ALERT SERVICE BULLETIN

NO. 205-09-101

MODEL AFFECTED: 205A & 205A-1

SUBJECT: 205-030-856-157/-159 ELEVATORS, ONE TIME INSPECTION OF.

Figure 1
Angle Measurements

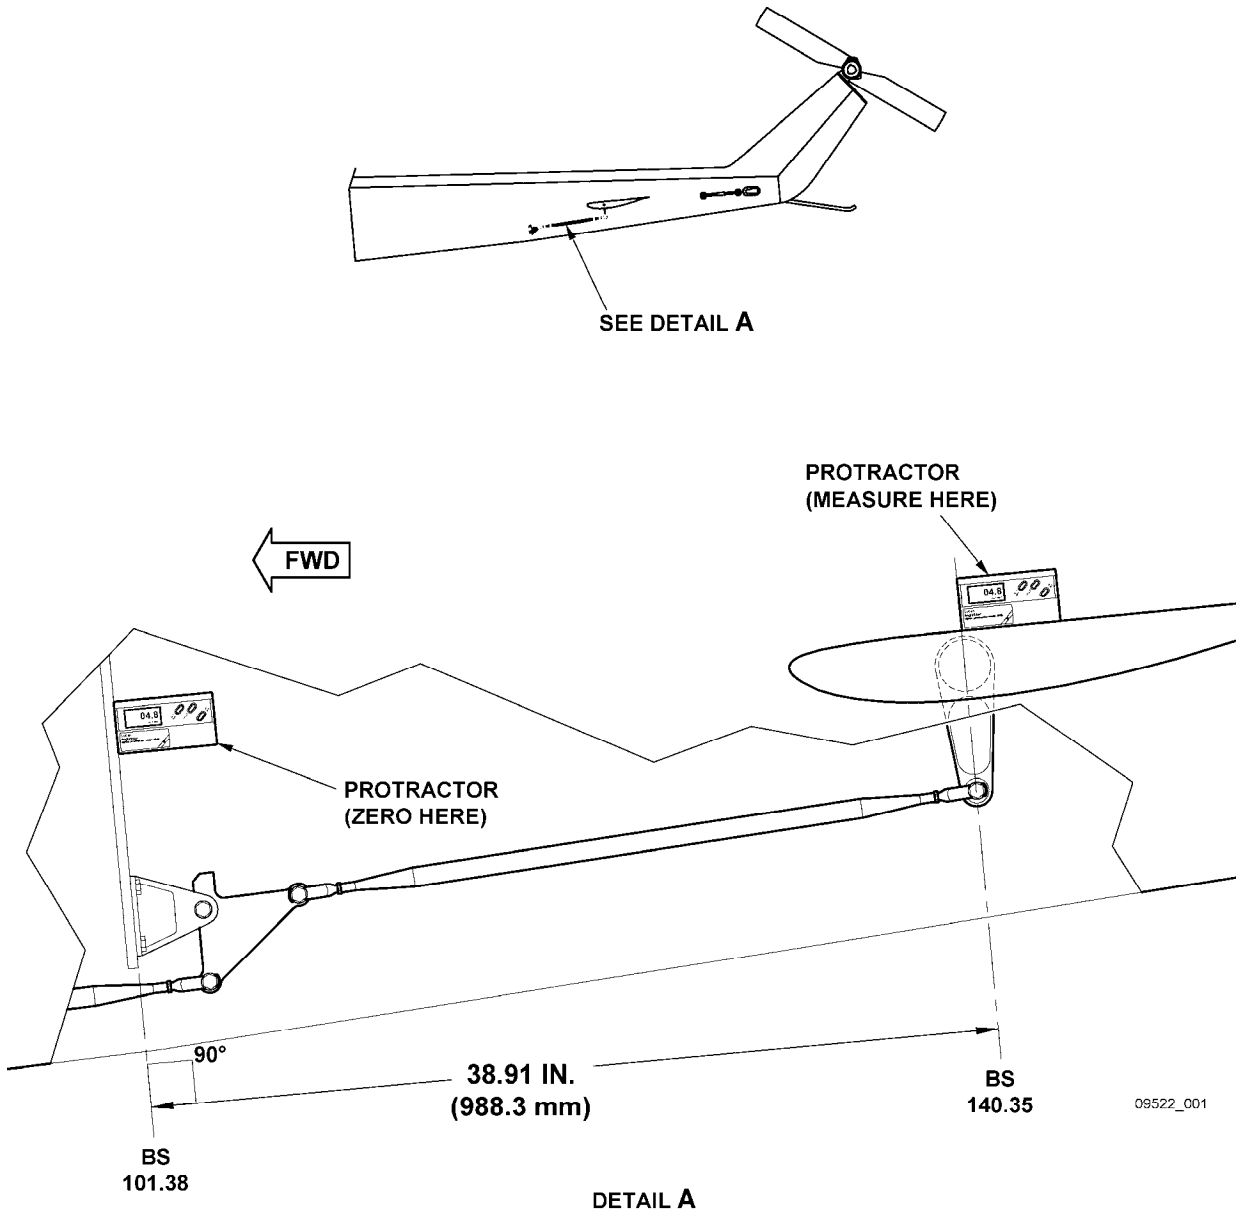
7. Move protractor to top skin of L/H Elevator and record the angle as Angle "B".
8. The correct value for Angle A is 0.00 +/- 0.50 degree. The correct value for Angle B is 1.00 +/- 0.50 degree.

- a. If Angle "A" and Angle "B" are not within their applicable tolerance, replace the RH elevator as per Maintenance Manual within the next 100 flight-hours and proceed to Part II thereafter.

- b. If Angle "A" is not within its applicable tolerance but Angle "B" is within its applicable tolerance, replace the RH elevator as per Maintenance Manual within the next 600 flight-hours and proceed to Part II thereafter.

- c. If Angle "A" is within its applicable tolerance but Angle "B" is not within its applicable tolerance, replace LH elevator as per Maintenance Manual within the next 100 flight-hours. No further action is required. Go to Part II, step 6.

- d. If Angle "A" and Angle "B" are both within their applicable tolerance, both elevators are compliant and no further action is required. Go to Part II, step 6.
